**TENDER FOR RE-CONSTRUCTION OF NORTH JETTY AT NAVAL BASE, KOCHI ON  
ENGINEERING, PROCUREMENT AND CONSTRUCTION CONTRACT BASIS**

(T10/T-1910/2020-C)

**ADDENDUM / CORRIGENDUM NO.5**

DRAWING NUMBER: 60614746-DWG - TD - 0000 - GN-1001 REV: 1

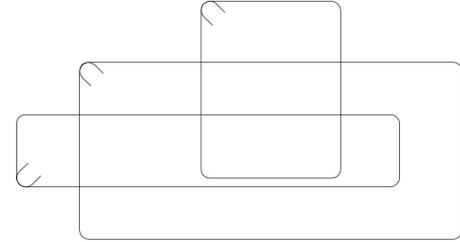
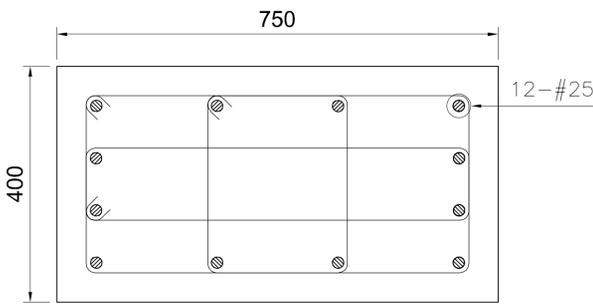
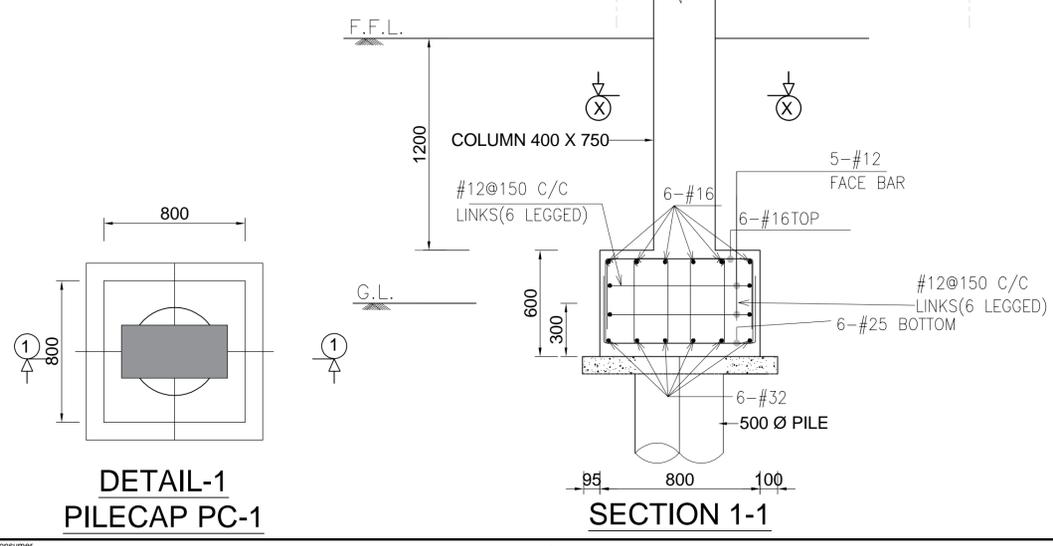
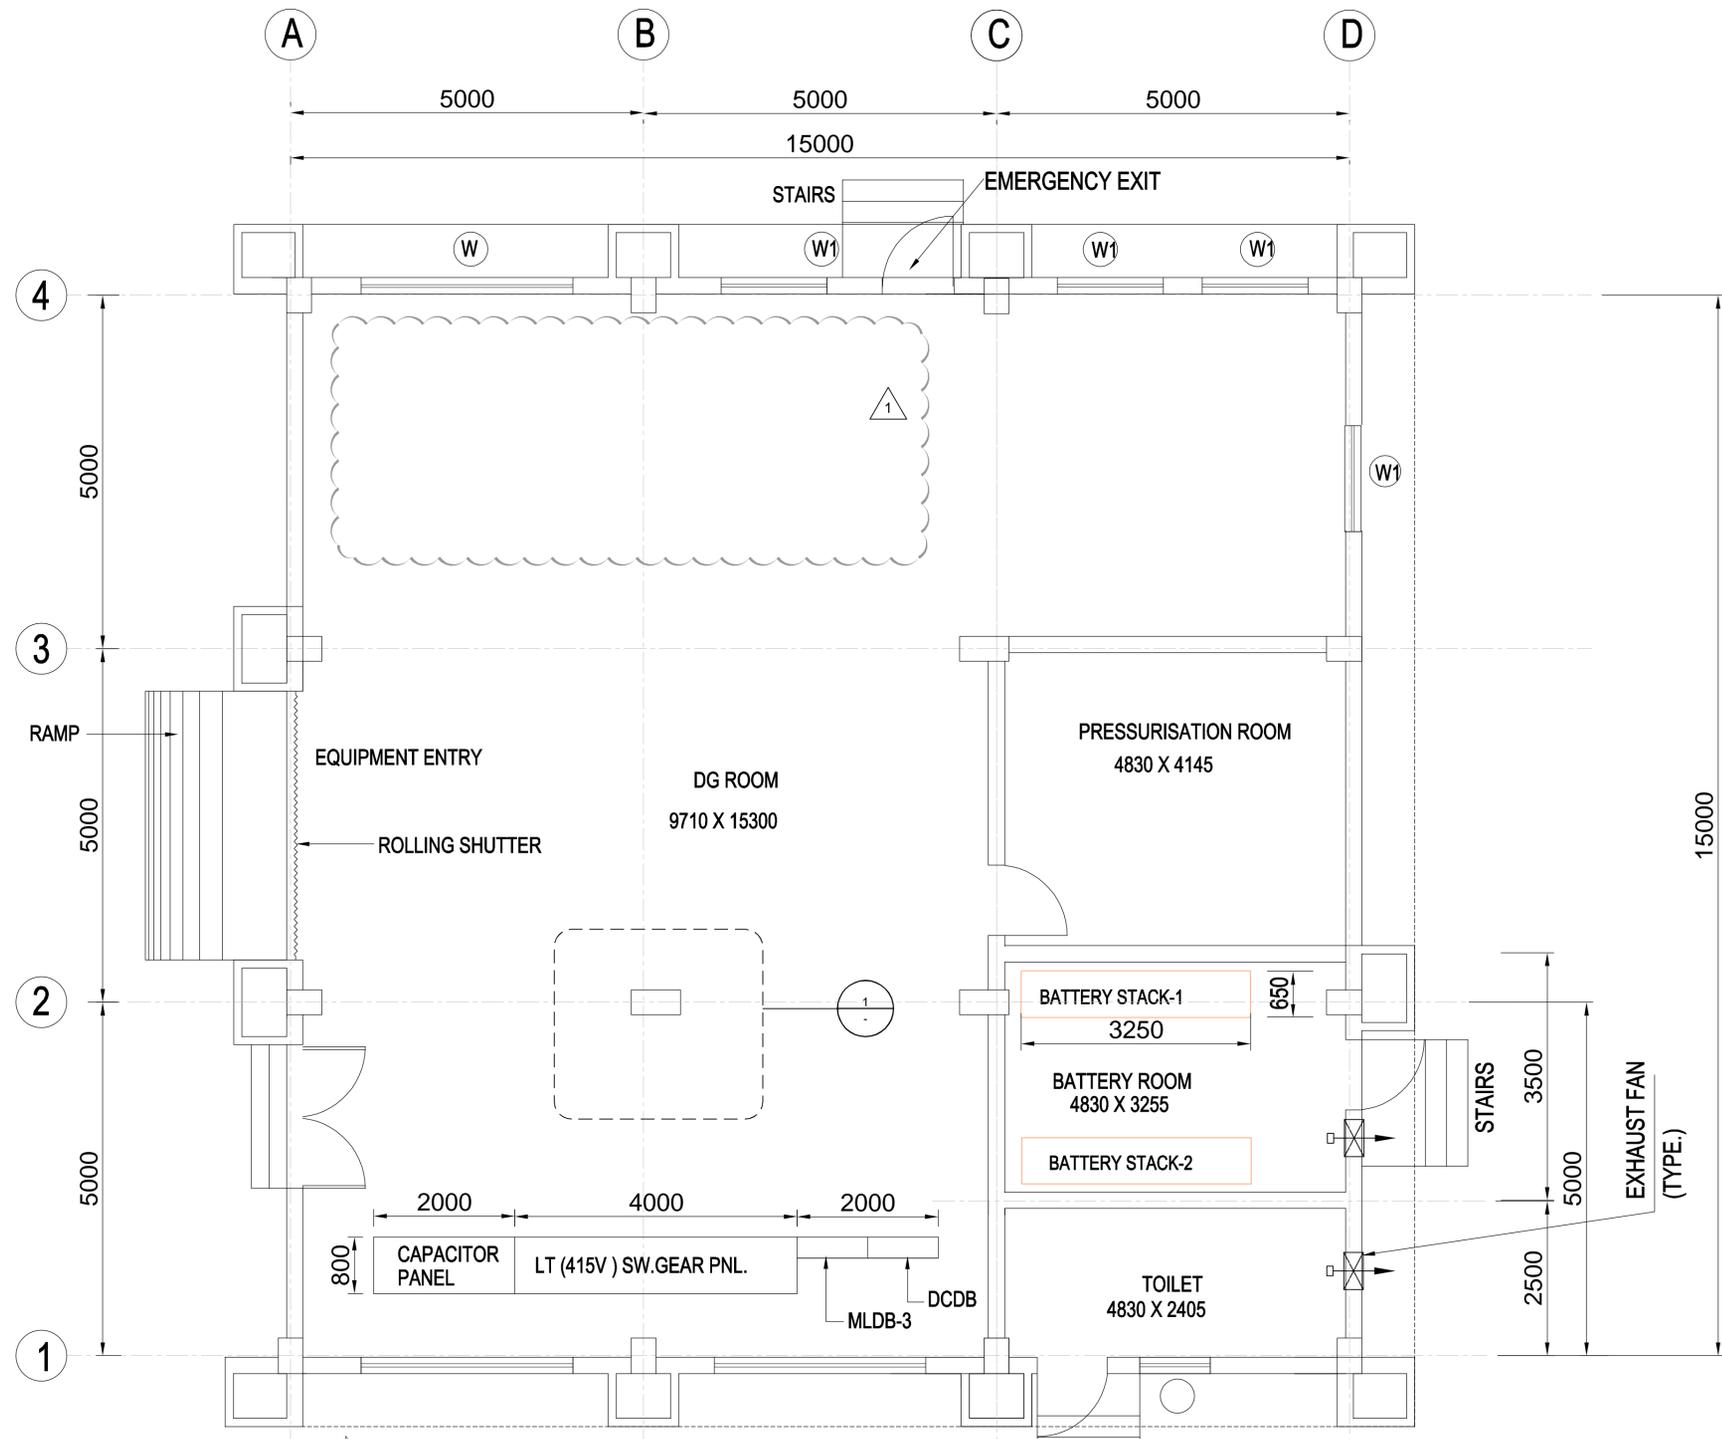
REV.	DATE	DESCRIPTION	DR.	CH.	APR.
1	20.02.2020	EXISTING MOORING DOLPHIN IS SHOWN	SV	TS	SG

DRAWING NUMBER: 60614746-DWG - TD - 0000 - PL - 3006

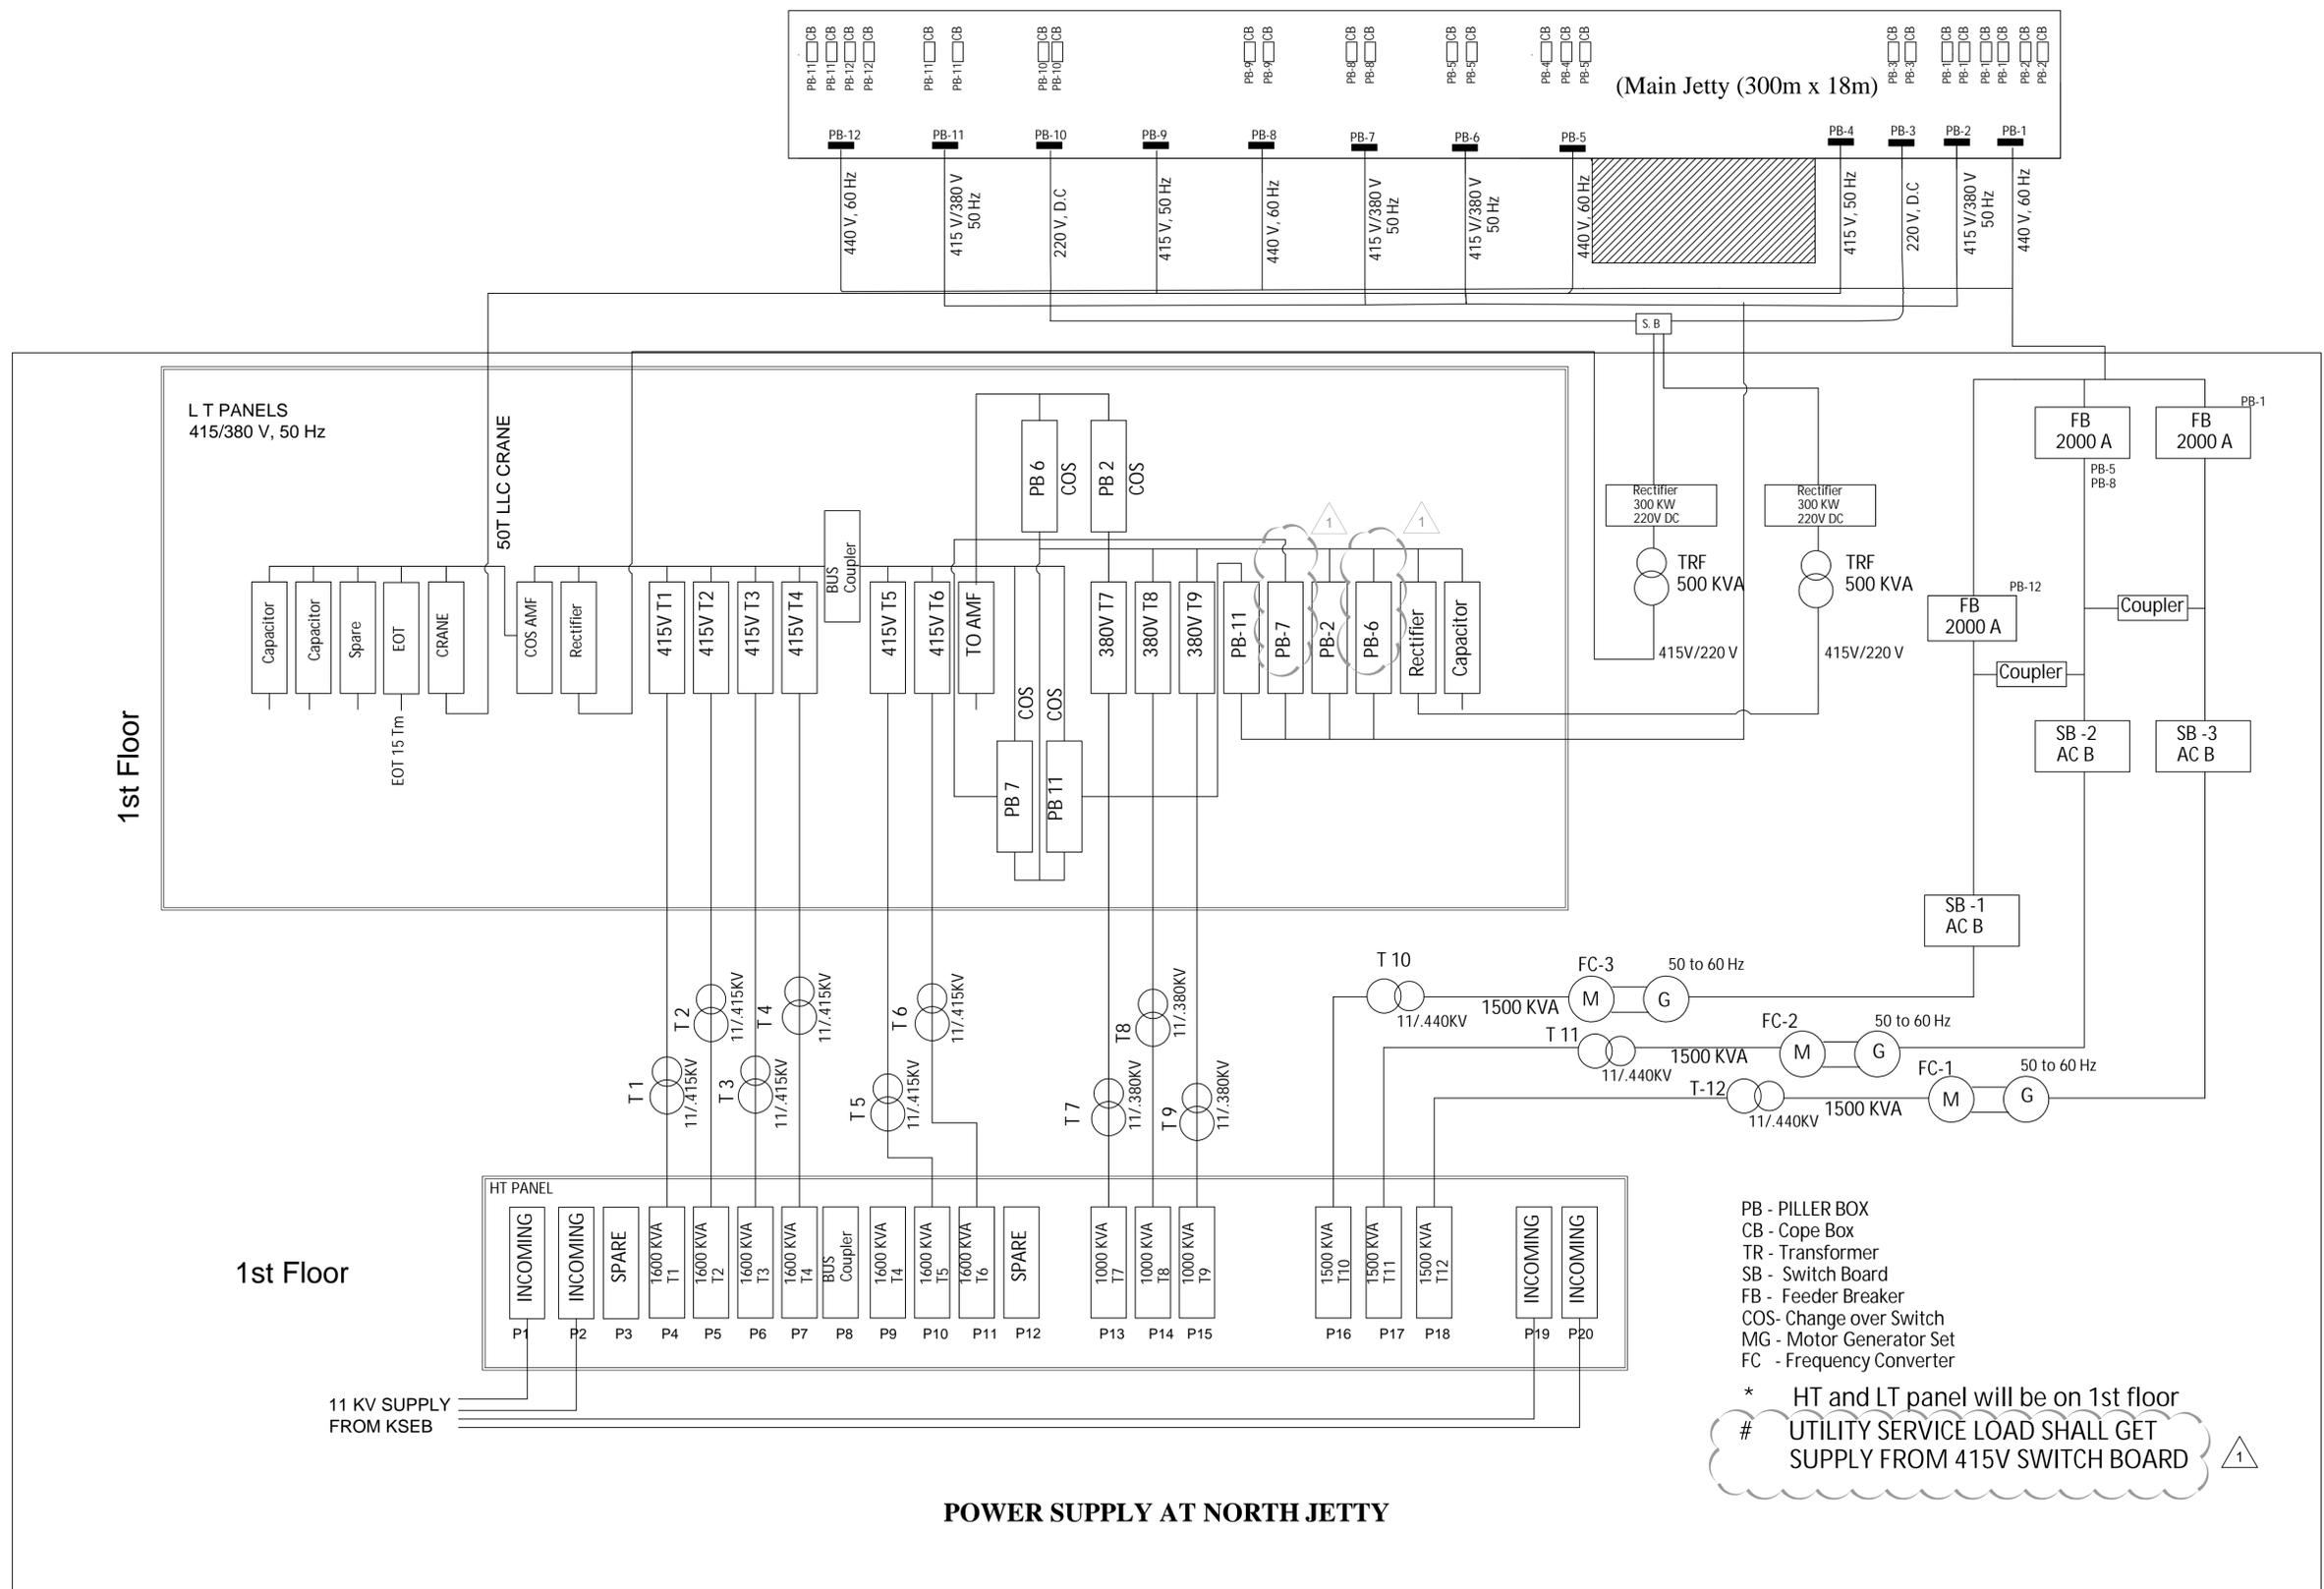
REV.	DATE	DESCRIPTION	SV	TS	SG
1	20.02.2020	HT SW. GEAR PANEL DELETE	SV	TS	SG
